## REVISED RESPONSE TO REQUEST FOR ADDITIONAL INFORMATION

### APR1400 Design Certification

Docket No. 52-046

RAI No.: 252-8299  
SRP Section: 03.07.02 – Seismic System Analysis  
Application Section: 3.7.2  
Date of RAI Issue: 10/19/2015

The 4%-damped ISRS of the SSW and the slabs that are modeled in the RCB seismic analysis model are compared between two models as presented in Figures 7 through 15.

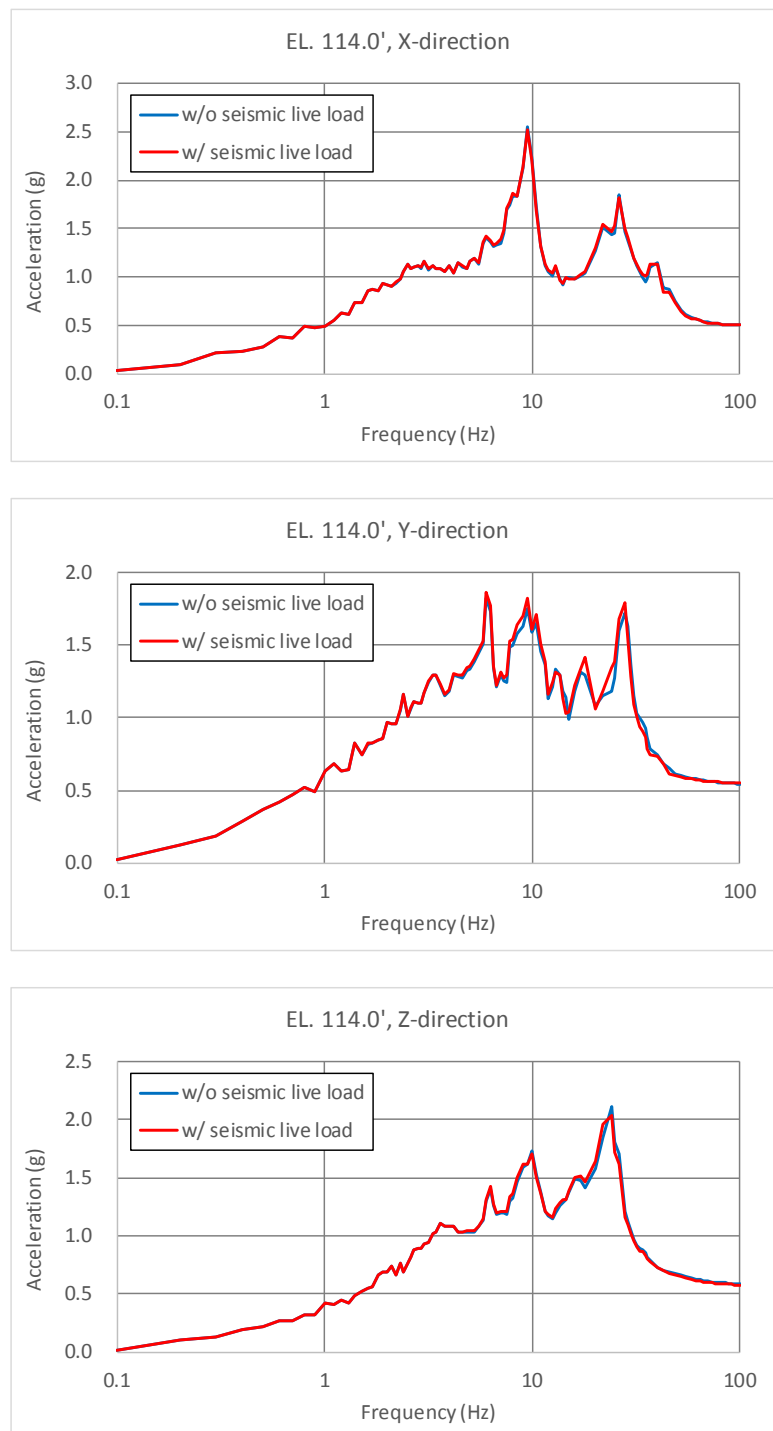
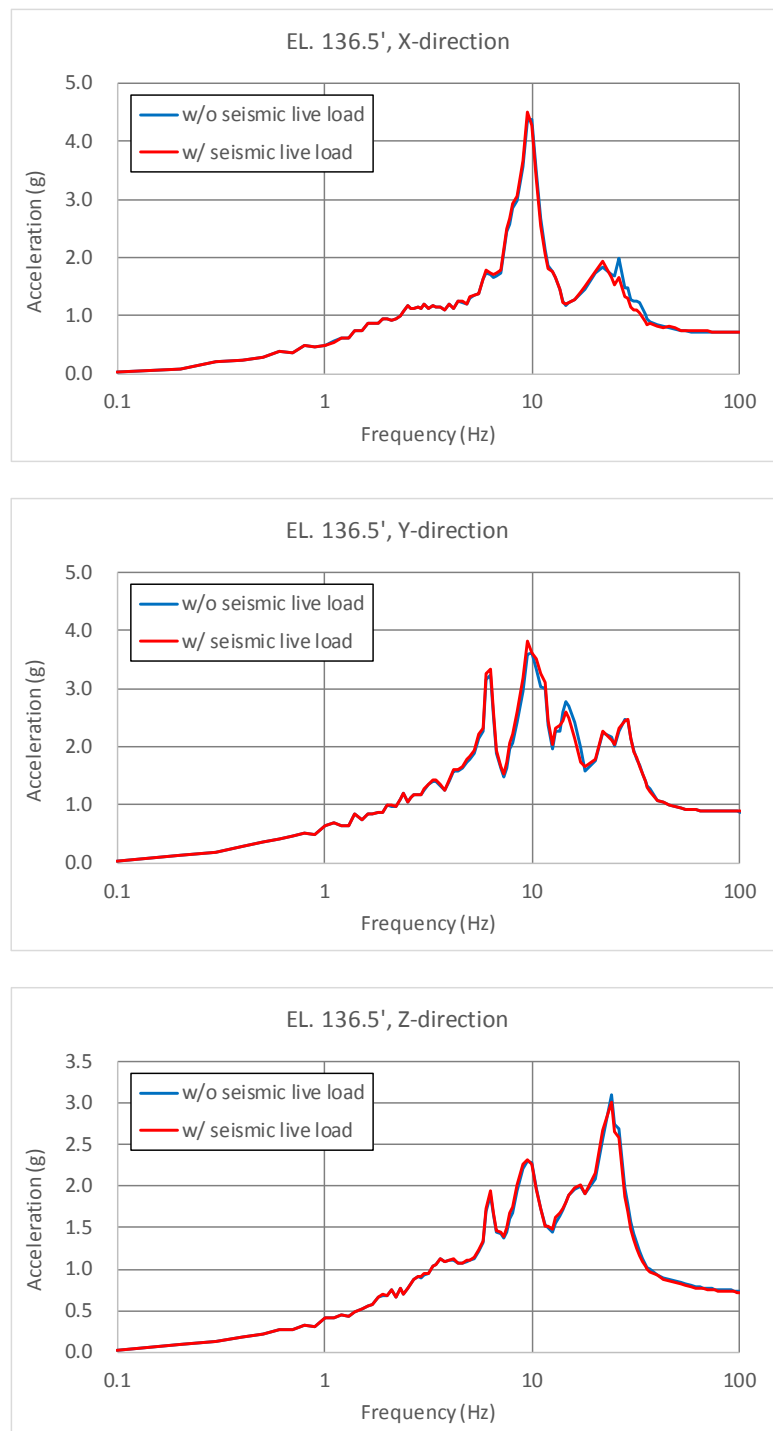
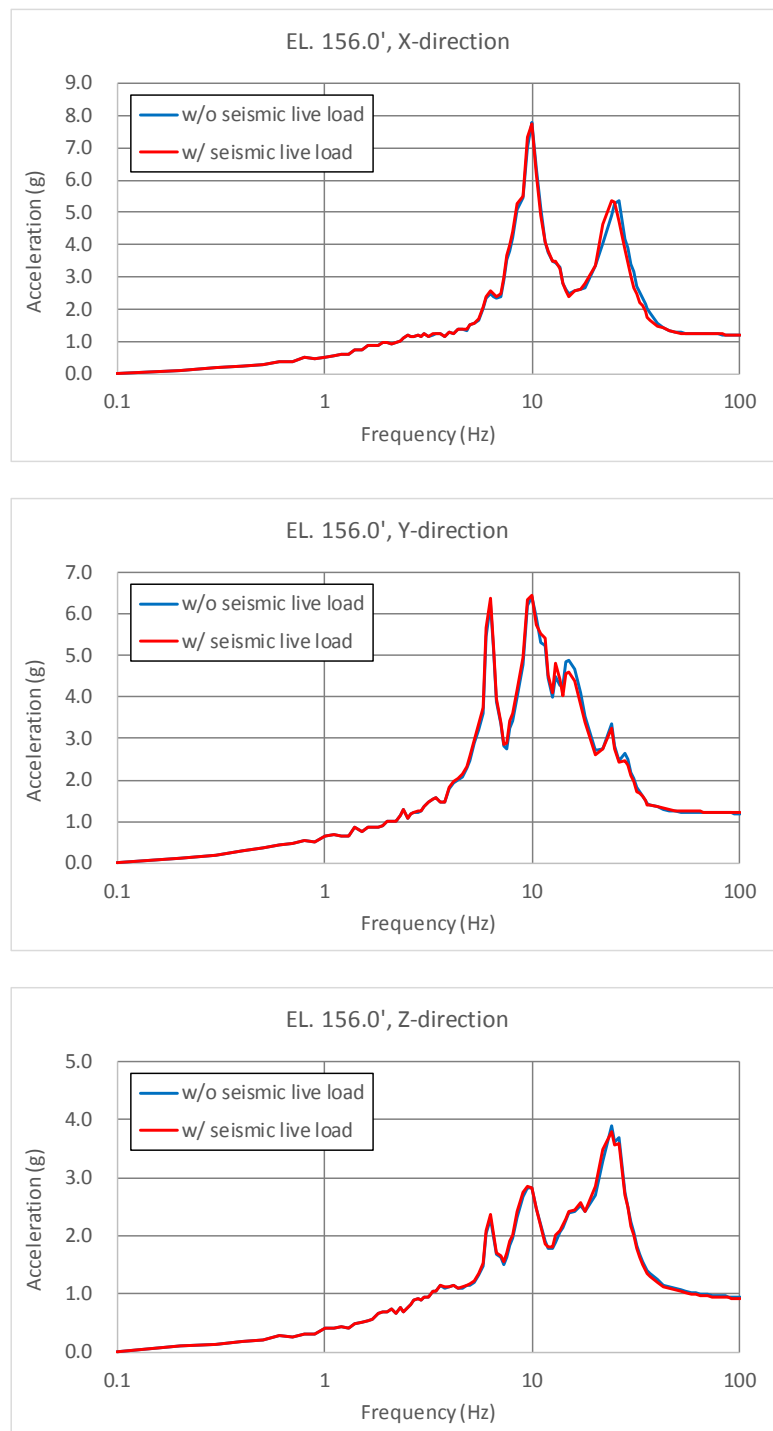
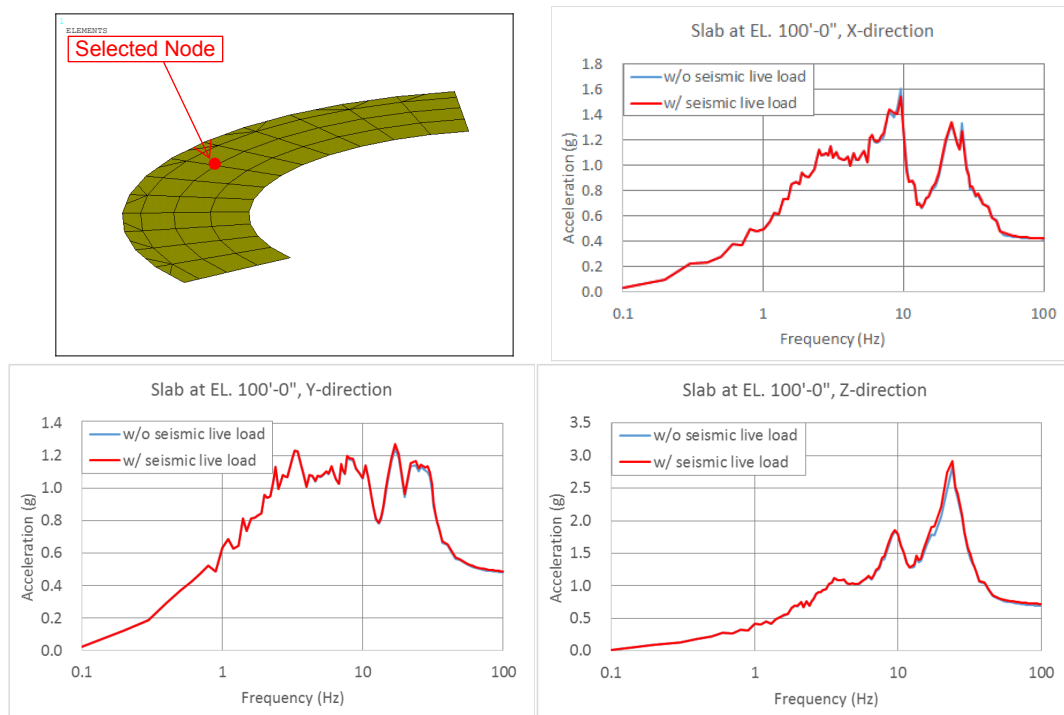
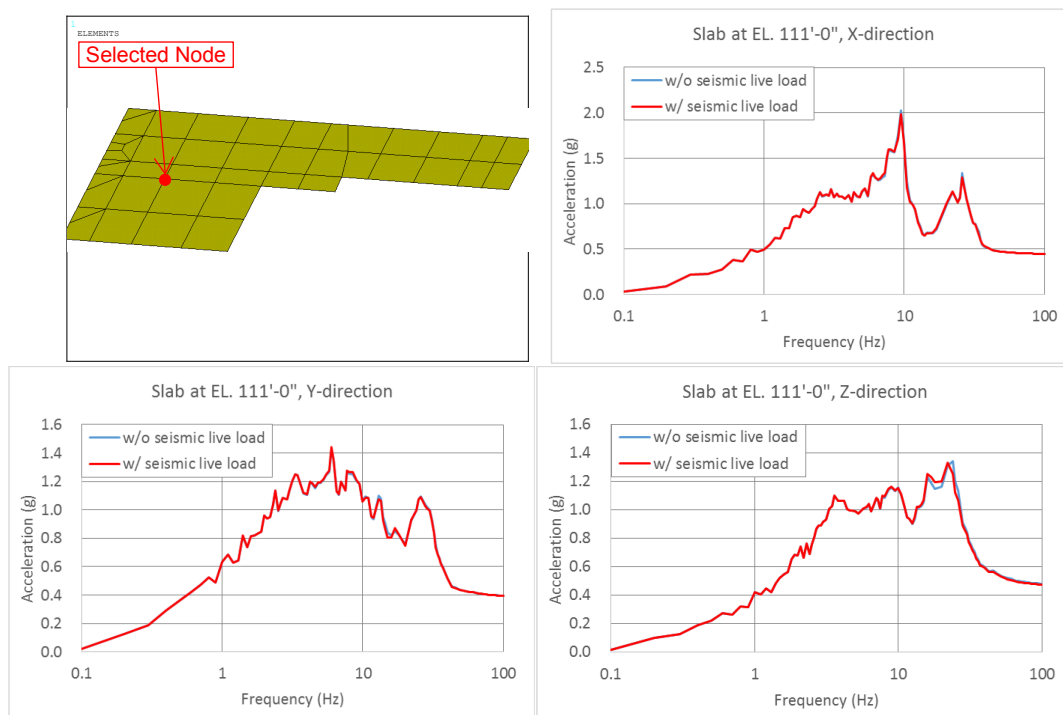
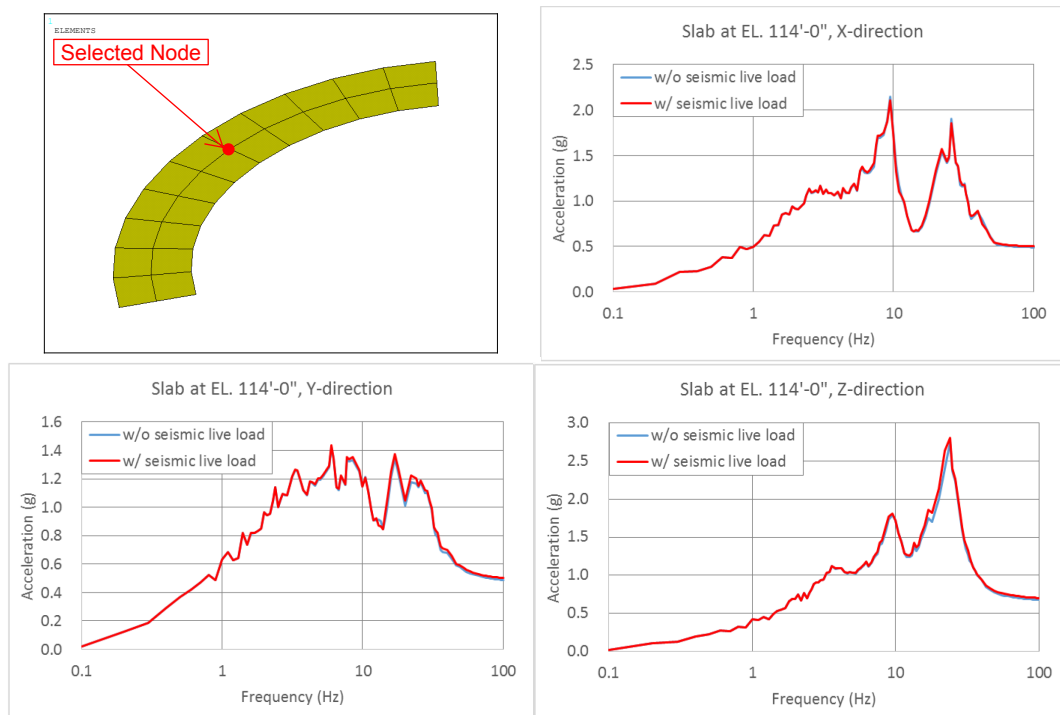
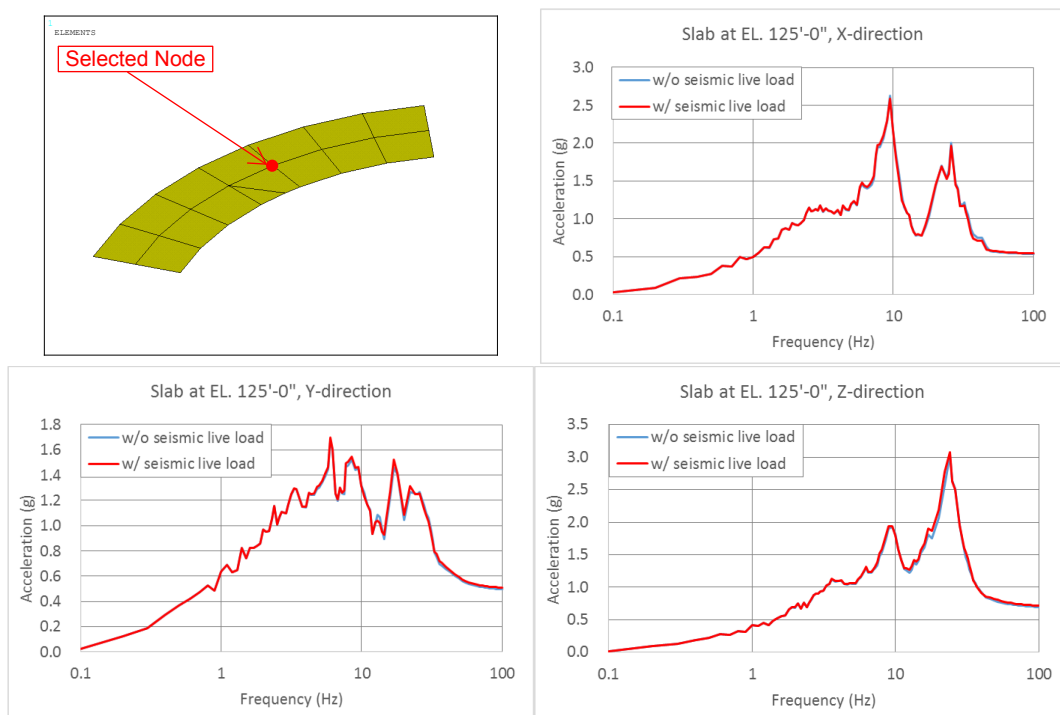
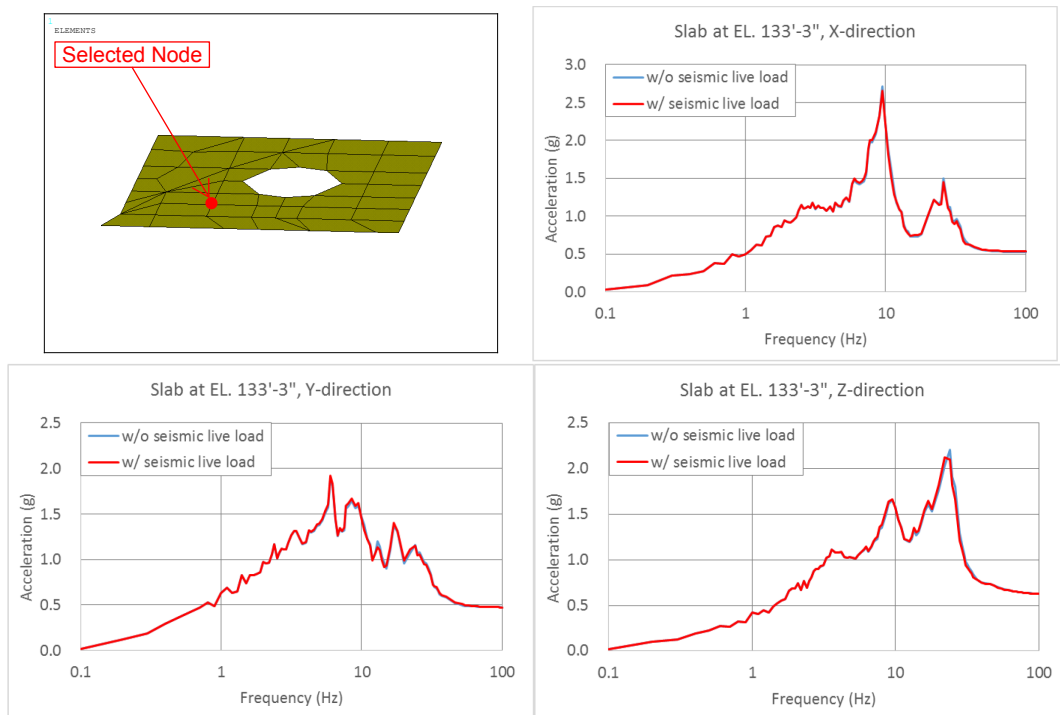
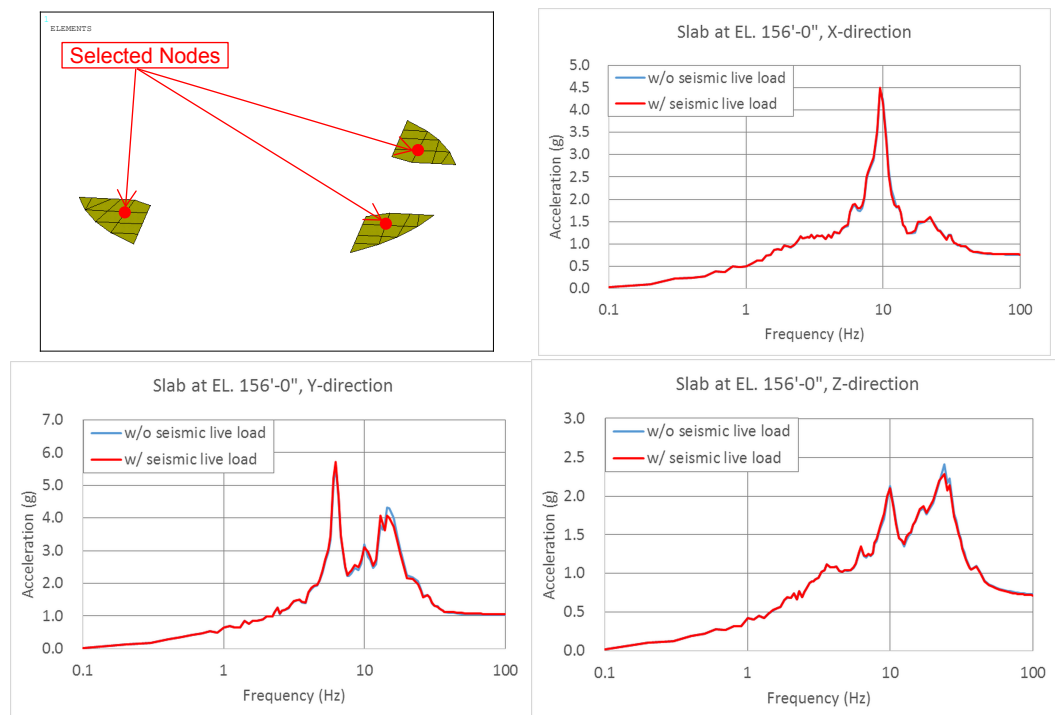
SRP Section 3.7.2.II.3D provides the acceptance criteria regarding the representation of floor loads, live loads, and major equipment in a dynamic model. In addressing these SRP criteria, DCD Section 3.7.2.3.3 includes a description of masses that are assumed to contribute to the inertial forces in the seismic analyses. However, this DCD section did not specify the magnitude of such masses. For example, based on the description in DCD Section 3.7.2.3.3, it could be inferred that 100% of the live load is used in the seismic load case. The staff review finds that Section 3.2.5 and Table 4-7 in APR1400-E-S-NR-14002-P,

for the RCB and AB, respectively, provide additional information on the magnitude of the masses described in DCD Section 3.7.2.3.3. Section 3.2.5 in APR1400-E-S-NR-14002-P states that 25 % of floor live load or 75% of snow load are applied on the roof of the containment which appears to conflict with DCD Section 3.7.2.3.3. Based on these two statements it is not clear to the staff what floor live load has been considered on all floors of the reactor containment building. Therefore the staff request the applicant to clarify in the DCD how the SRP Section criteria regarding floor loads is addressed in the models used for seismic analysis.

Since the slabs in the RCB are not large, and the increase of the weight due to the addition of the seismic live load 50 psf (total 1,650 kips) is not great compared to the existing weight of the internal structure walls and slabs (total 183,000 kips), the effect of the seismic live load on the seismic responses of the RCB is expected to be very small.

To evaluate the effect of seismic live load which is not considered in the RCB, a study is performed using the ANSYS coarse mesh model of the RCB. The transient time history analyses are performed with the fixed-base condition using two ANSYS models. One is the original ANSYS coarse mesh model of the RCB, and the other is modified model considering the seismic live load of all slabs in the RCB, whether the slabs are modeled or not. For the slabs which are not modeled, the masses equivalent to the seismic live loads which are applied to the slabs are added to the SSW of the modified model. For the slabs in the model, the lumped masses equivalent to the seismic live loads are added to the nodes of the slabs in the modified model. The CSDRS input time histories of the APR1400 are used as the input time histories for the transient time history analyses. The analyses are performed for individual directions independently. Then, the ISRS results of the three directions are combined using the square root of the sum of the squares (SRSS) method.

Since the SSW supports one end side of most slabs in the RCB, the ISRS comparisons of the walls are conducted for SSW only. The nodes, which were used for enveloping the APR1400 ISRS of the SSW, are identically used to generate the enveloped ISRS for the comparisons. For the ISRS comparisons of the slabs that are modeled in the RCB seismic analysis model, the ISRS of the center nodes in each slab are selected and compared as shown in Figures 10 through 15. As shown in the comparison figures, the variation of ISRS due to the consideration of the seismic live load in the RCB seismic analysis model is negligibly small. Therefore, it can be concluded that the effect of seismic live load on the RCB seismic response is insignificant.

Figure 16. Tapered Section in Primary Shield Wall

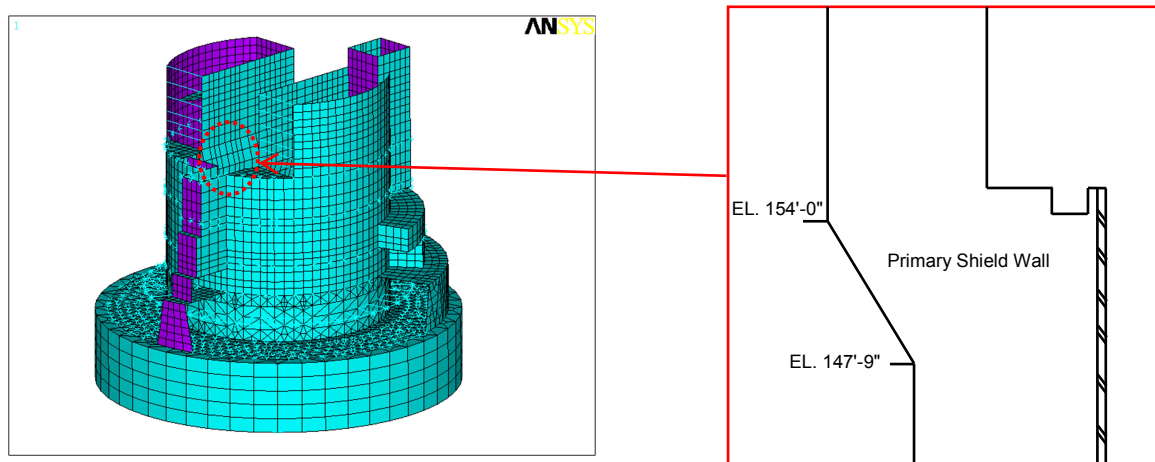
As described in Section 3.2.10 and shown Figure 3-3 in APR1400-E-S-NR-14002-P, shell elements are used to model the shield wall portion of the primary shield wall (PSW) from EL 130' to EL 191.' Given the geometry of the PSW, the use of thick shell elements may be more appropriate for this portion of the PSW. he geometry of the PSW, the use of thick shell elements may be more appropriate for this portion of the PSW. Additionally, based on Figure 3-3, a portion of these walls modeled with shell elements, appears to be not in plane with respect to the plane of each respective wall. Therefore to assist the staff in evaluating the adequacy of the FEM for the PSW, the staff requests the applicant to clarify why the shell element selected for the PSW model is appropriate as opposed to using a thick shell element formulation. Additionally, please describe the modeling approach and the basis of the shell portion of the walls including the location of plates oriented in non-parallel planes.

- c) The original SASSI program was developed in the 1980's and has only the LCCT9 thin shell element, which was adopted from the SAP IV structural analysis program. This same version of the SASSI code was adopted by many company-specific versions of SASSI. ACS SASSI 2.3 also has only the LCCT9 thin shell element. Many versions of SASSI, including ACS SASSI 2.3, do not have thick shell element available for structural modeling. This is the reason why thick shell elements have not been used for modeling the PSW by the ANSYS program.

Use of thick or thin shell elements does not significantly affect the overall structural stiffness since the main stiffness of the shell structures (containment shell, PSW, SSW, etc.) are primarily due to in-plane stiffness.

The thickness and center axis of the PSW section are changed over EL. 147'-9" through EL. 154'-0", as shown in Figure 16. The portion of wall which is not in plane with respect to the plane of respective walls in Figure 3-3 of APR1400-E-S-NR-14002-P was intentionally modeled to represent the contour of the PSW.

Figure 17. Connection between RCS Supports and Solid Elements

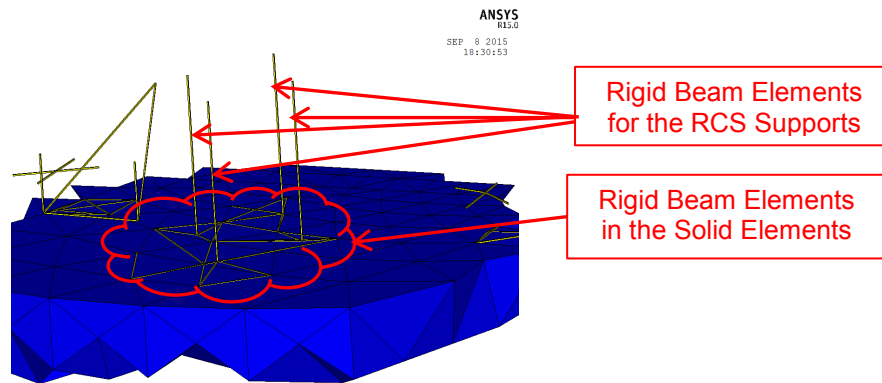
Staff review of APR1400-E-S-NR-14002-P finds that the nuclear island finite element model includes locations at which beam elements connect with solid elements (e.g. connections between the reactor coolant system model and the containment internal structure model). However, the staff did not find a description of how the degree of freedom compatibility is addressed for transitions between beam and solid elements. Therefore the staff requests the applicant to provide such description, including a graphical representation of the transition between beam and solid elements.

- d) The degrees of freedom compatibility condition between the beam elements of the reactor coolant system (RCS) and solid elements of the primary shield wall (PSW) and the secondary shield wall (SSW) was satisfied by using the rigid beam elements at the beam-to-wall support points covering the footprint of the RCS support brackets. The RCS supports are modeled as rigid beam elements and connected with other rigid beam elements in the solid elements which represent the PSW and the SSW.

Figure 17 shows the connection between the RCS supports (rigid beam) and the building model (solid elements). Technical report APR1400-E-S-NR-14002-P will be revised, as indicated in Attachment 3 to this response to incorporate the description of the beam-to-solid element connection.
